STAFF REPORT
COMMUNITY DEVELOPMENT DEPARTMENT

HEARING DATE: 3/15/2022
 TO: Mayor & City Council
 FROM: Alan Tiefenbach
 208-884-5533
 SUBJECT: AZ, PP - H-2021-0074
 Jamestown Ranch Subdivision
 LOCATION: Parcels S0434223150, S0434212970, S0434212965, S0434212920, and 4023 W. McMillian Rd, located at the southeast corner of the N. Black Cat / W. McMillian Rd intersection.

Annexation with the R-8 zoning district, and preliminary plat to allow 294 building lots and 25 common lots on 80.3 acres of land.

C. Color Landscape Plan (date: ~~9/9/2021~~ 2/7/22)

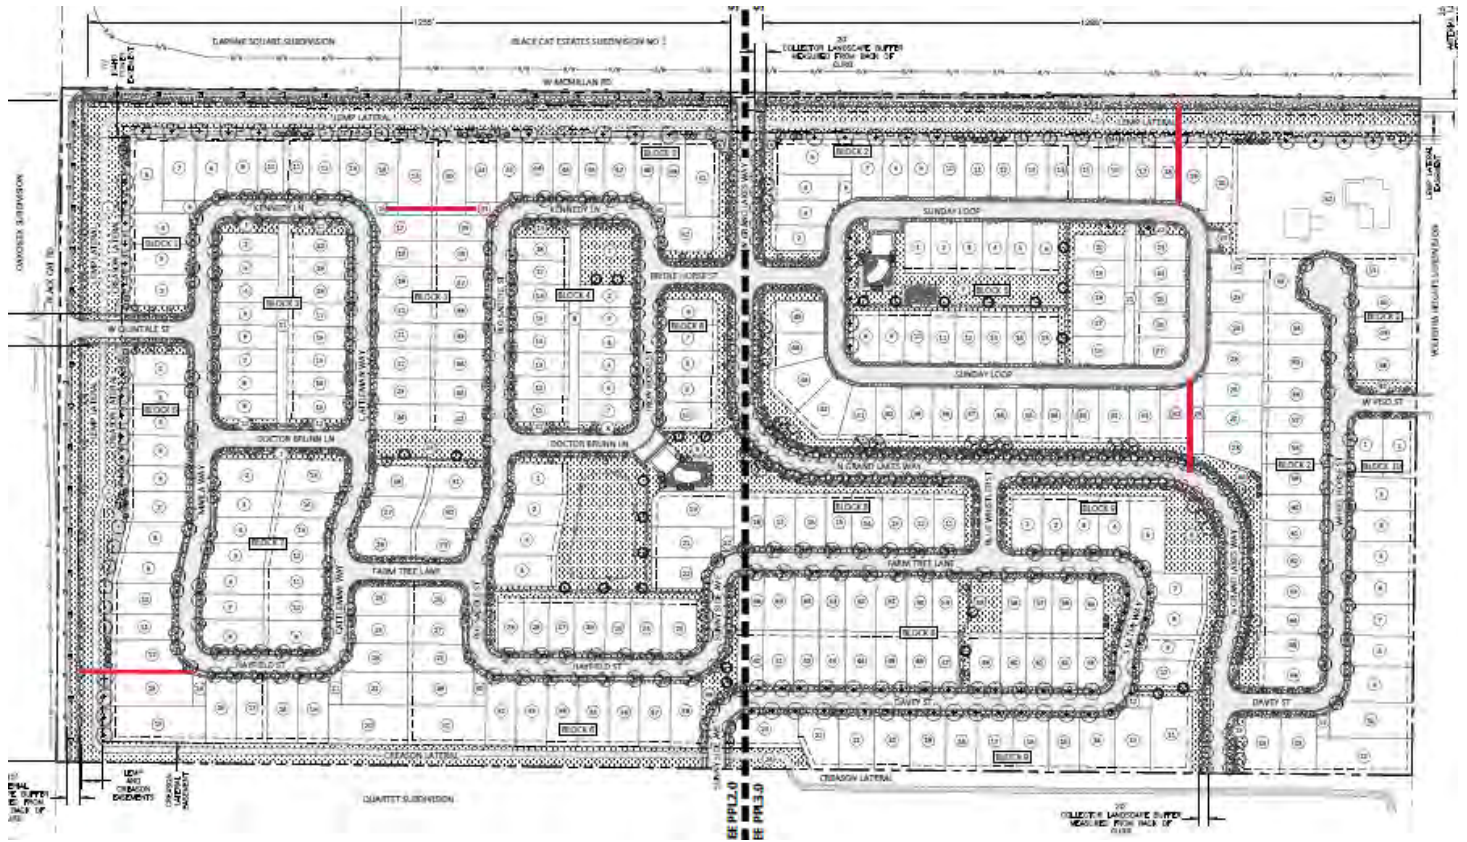
UDC 11-2A-6 requires 25 ft. wide buffers along arterial roads (N. Black Cat Rd. and W. McMillian Rd.) and 20 ft. wide buffers required along collector roads (N. Grand Lakes Way). The landscape plan reflects a buffer from the N. Black Cat Rd. edge of pavement ranging in width from between 70 ft. from the at the south to 120 ft. wide at the north. The Creason Lateral and the Lemp Lateral as well as a maintenance road are both located within this buffer, although there is an additional landscape strip width of 25 ft. wide between the laterals and the exterior property fences. Along W. McMillian Rd. to the north, there is a buffer ranging in width from between 64 ft. and 80 ft. in width. The Creason Lateral is also located in this buffer; there are landscape strips of at least 25 ft. in width between this lateral and the exterior property fences. Both arterial buffers meet the minimum requirement for at least one tree per 35 ft. in width; the areas containing laterals are shown to be sod. Buffers of at least 30 ft. in width are provided along N. Grand Lakes Way (20 ft. is required). 8 ft wide landscaped parkways are provided along most of the internal local streets with the exception of the Sunday Loop at the NE portion of the site. The landscape plan includes 11.63 acres of qualified open space (14.5%) as will be discussed in the Qualified Open Space and Amenities sections below.

The common open space exhibit indicates the arterial buffers as “non-qualified open space” whereas ½ of this area can be counted as qualified open space per UDC 11-3G-3.

D. Landscape Plan Marked Up with Recommended Pathway Connections (date: 9/9/2021)

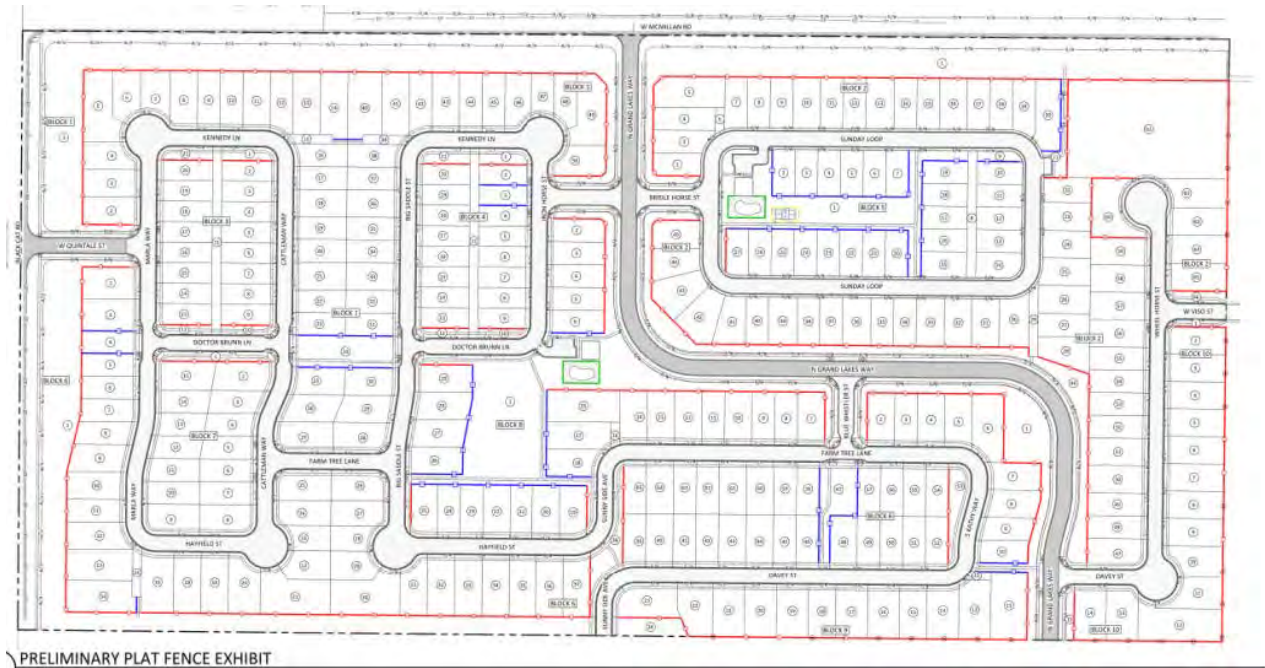
Staff does believe there are portions of the development where there could be more direct non-motorized connectivity to the amenities and common open space within the development as well as to the detached sidewalk along N. Black Cat Rd. Staff has red-marked these recommended connections on the landscape plan below.

A 10 ft. wide detached pathway is reflected along W. McMillian Rd. which is consistent with the alignment shown on the Pathways Master Plan. There is also a 10 ft. wide detached pathway along one side of N. Grand Lakes Way. (the internal collector) which connects to the W. McMillian Rd. pathway. Several micro-pathways are reflected providing connectivity to internal portions of the development. As mentioned in the Comprehensive Plan analysis above, to improve more direct pedestrian connectivity, staff is recommending additional micro-pathway connections (red-marked on the landscape plan below).

~~3. Prior to final plat, the Landscape Plan included in Section VI, dated 9/9//21, shall be revised to reflect the red marked pathway connections as illustrated in Exhibit D.~~
